MEETING OF THE HISTORIC DISTRICT COMMISSION

6:30 p.m. May 07, 2020

Staff Report – May, 2020

March 29, 2019 Administrative Approval: Sheet 10R - North Elevation

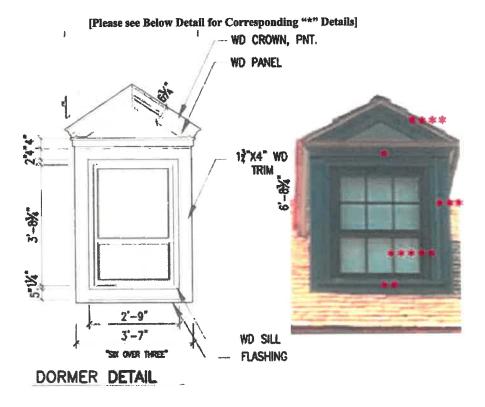
Alterations to the Approved Plan:

- A. 21'-11.5" x 11.5' deck omitted.
- B. Right stairs and landing shifted several feet to right (railing is no longer aligned with
- C. ADA ramp doglegs to right.

5. Doors -

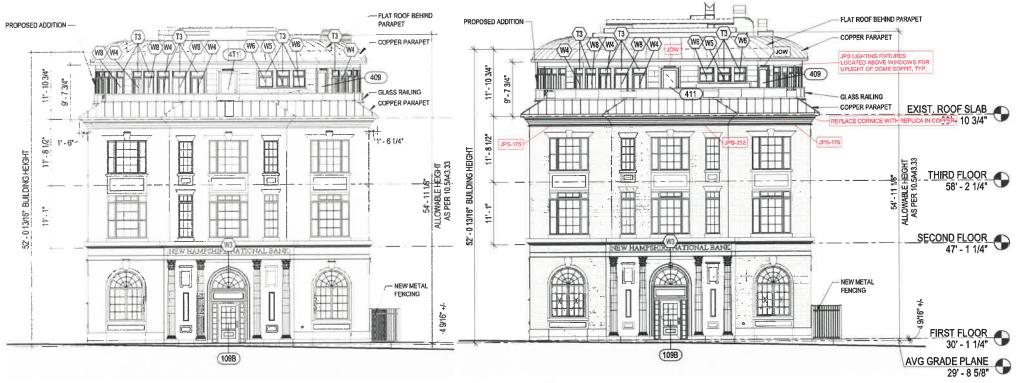
- Slightly reduced window sizes at fourth floor windows W4, W6, & W8 per structural steel coordination.
- Fanlight transoms over front and rear entry doors will be clear finished custom built mahogany, instead of copper-clad wood.
- New construction 4th floor aluminum clad wood windows are revised from Kolbe Ultra, color: Shale; to Marvin Ultimate, color: Hampton Sage.
- New construction east/rear elevation windows W7 & W15 and their adjacent trim to be aluminum clad wood (Marvin Ultimate) instead of copper clad wood.

- First floor entry doors (4) will be clear finished custom built mahogany, instead of copper-clad wood.
- New doors on upper floor roof decks will be commercial aluminum storefront, instead of aluminum clad wood. Door manufacturer to be Kawneer medium stile or equivalent, factory finished color to match Marvin Windows Hampton Sage.
- Window W9 at 2nd & 3rd floor balconies is revised from a full height window, to a combination sidelight unit with adjacent door.

PROPOSED NORTH ELEVATION

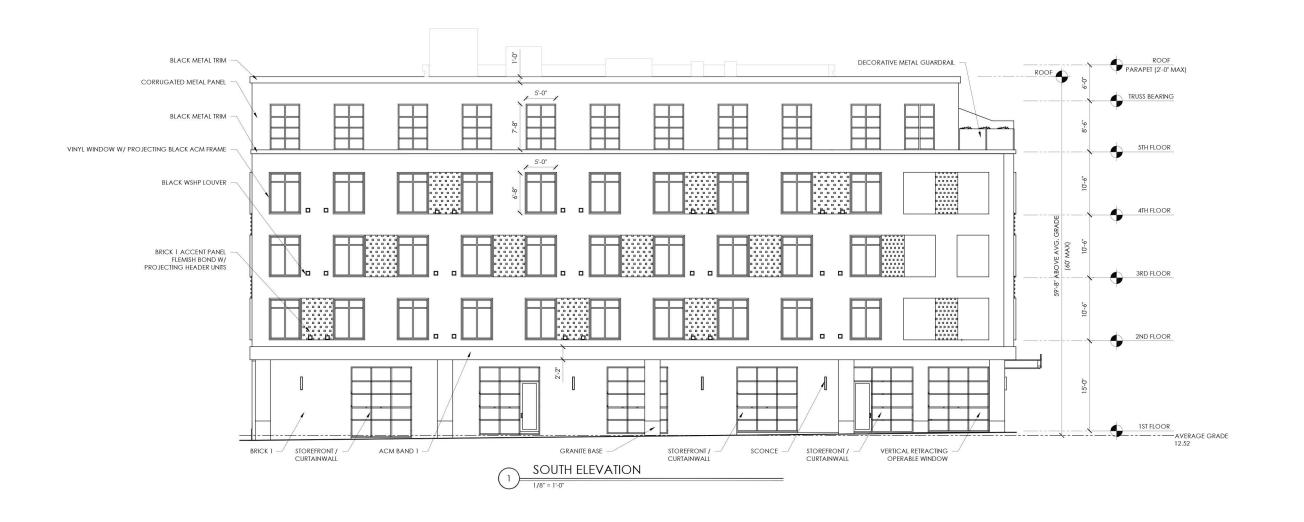
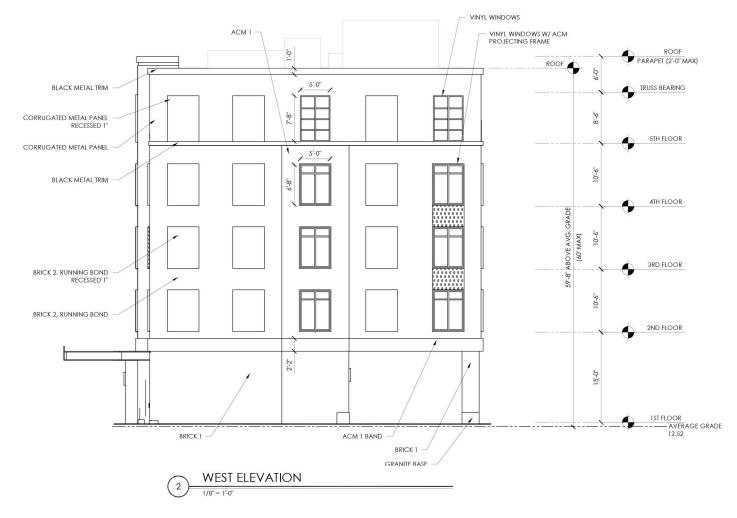
Members suggested alternative designs to better differentiate the proposed hotel from AC Hotel.
 Members felt the pedestrian passageway needed further refinement in order to be more inviting to
 the public. Other comments suggested other ground-floor modifications to give the building a
 more uniform base and a clearly distinguished entrance. Adding windows and transparency to
 the brick stairwell was also suggested.
